DART SERVICE INSTRUCTION

TO AMEND INSTALLATION INSTRUCTIONS IIN-D350-689 REV. B

AND INSTRUCTIONS FOR CONTINUED AIRWORTHINESS ICA-D350-689 REV. 1

REF. TCCA STC: SH02-33
REF. FAA STC: SR01620NY
REF. EASA STC: EASA.IM.R.S.01453
REF. TCA STC: 2005S03-09

FIGURE 1: UPDATES TO CROSS SECTIONS F-F AND M-M
With reference to Figures 5 and 7 of IIN-D350-689
(Figures 25-5 and 25-7 of ICA-D350-689)

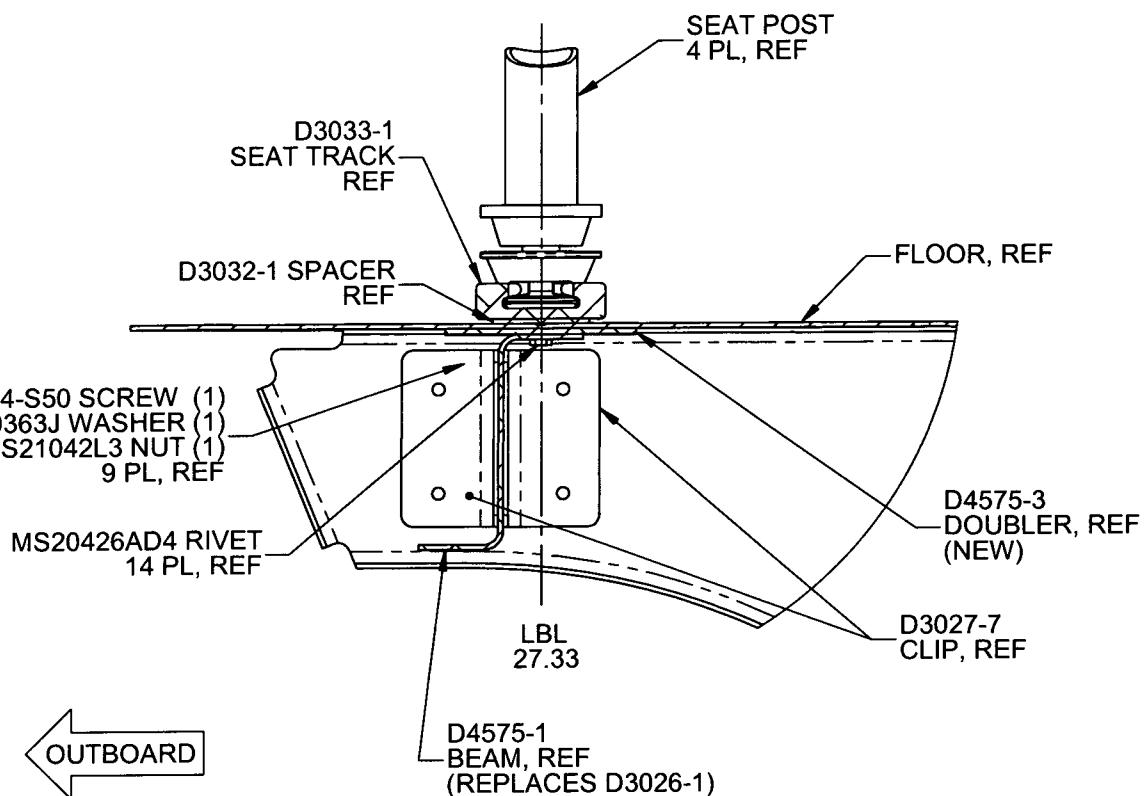
2.0 INSTALLATION CHANGES FOR D350-689-013

Section 3.9, *INSTALLATION OF D350-689-013 FLOOR PROVISIONS KIT* (pages 4 and 5 of IIN-D350-689), is changed as follows:

Item 3.3.15 is:

If there is an existing stringer at LBL 27.33, it will need to be removed from that location. Locate D4575-1 Beam, D4575-3 Doubler, and D3032-1 Spacer as shown in Figure 1 of this Service Instruction. Transfer drill existing holes from the aircraft floor to the D4575-1 Beam, D4575-3 Doubler, and D3032-1 Spacer. Ensure 1.0" to 1.5" rivet pitch and add additional holes if required. If there is no existing stringer, locate D4575-1 Beam, D4575-3 Doubler, and D3032-1 Spacer as shown in Figure 1 of this Service Instruction and drill Ø0.128" holes on a 1.0" to 1.5" pitch.

Note: Drill a Ø1.00" (Ø25.4 mm) hole in the D4575-1 Beam to clear extension tube of collective and cutout as required for clearance of collective opening and fwd bulkhead as shown in Figure 3 of this Service Instruction.

Item 3.3.17 is:

Counter sink holes in the D3032-1 Spacer for MS20426AD4 rivets. Install D4575-1 Beam, D4575-3 Doubler, and D3032-1 Spacer to floor using MS20426AD4 rivets.

FIGURE 2: UPDATES TO FIGURE 21 (IIN-D350-689) AND 25-21 (ICA-D350-689)
 With reference to Figures 19 and 20 of IIN-D350-689
 (Figures 25-19 and 25-20 of ICA-D350-689)

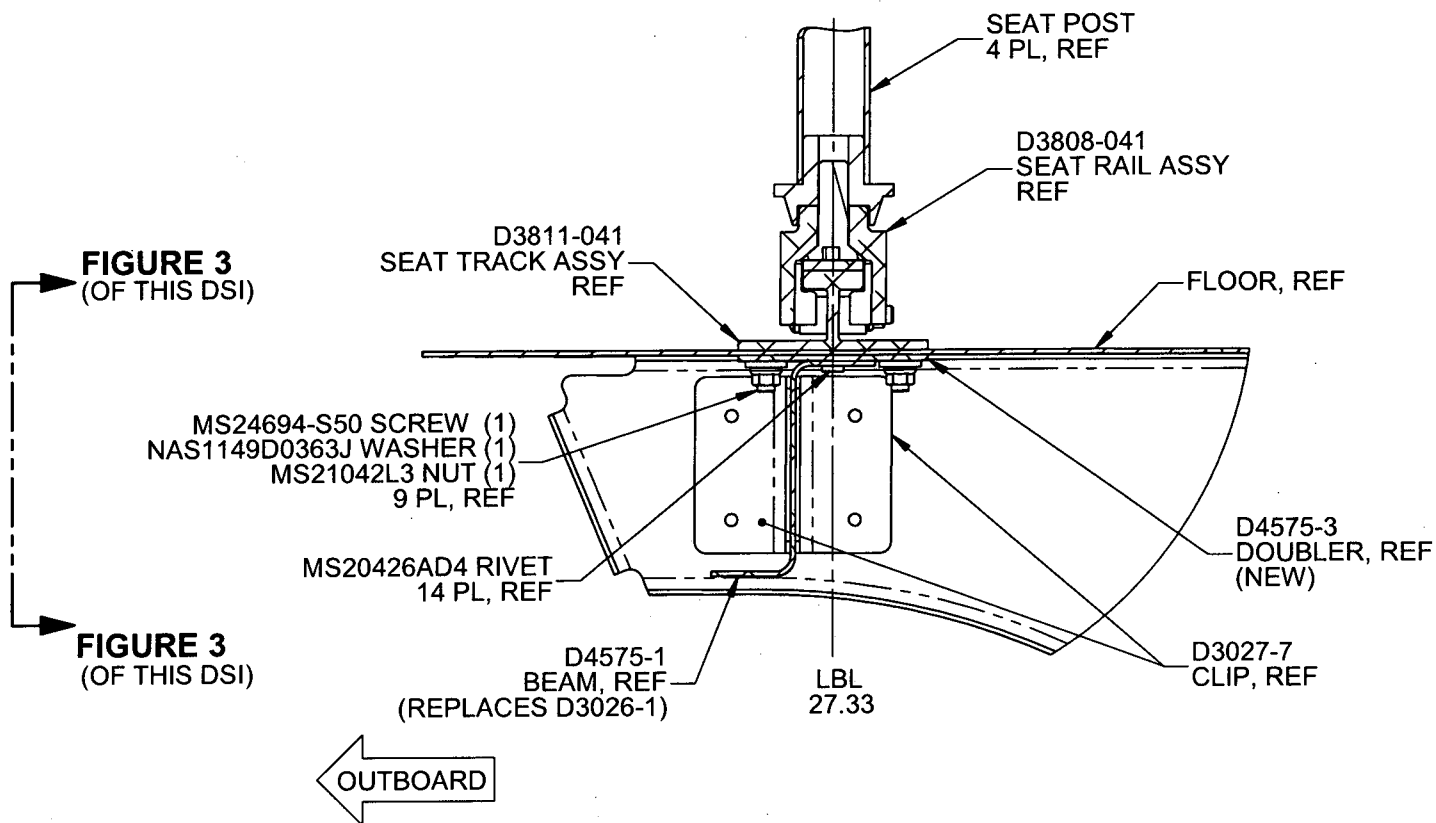
3.0 INSTALLATION CHANGES FOR D350-689-023

Section 3.9, *INSTALLATION OF D350-689-023 ENERGY ATTENUATING FLOOR PROVISIONS KIT* (pages 8 and 9 of IIN-D350-689), is changed as follows:

Item 3.9.8 is:

If there is an existing stringer at LBL 27.33, it will need to be removed from that location. Locate D4575-1 Beam and D4575-3 Doubler as shown in Figure 2 of this Service Instruction. Transfer drill existing holes from the aircraft floor to the D4575-1 Beam and D4575-3 Doubler. Ensure 1.0" to 1.5" rivet pitch and add additional holes if required. If there is no existing stringer, locate D4575-1 Beam and D4575-3 Doubler as shown in Figure 1 of this Service Instruction and drill Ø0.128" holes on a 1.0" to 1.5" pitch.

Item 3.9.10 is:

Attach D4575-1 Beam and D4575-3 Doubler to floor using qty (14) MS20426AD4 rivets.

Item 3.9.12 is no longer applicable:
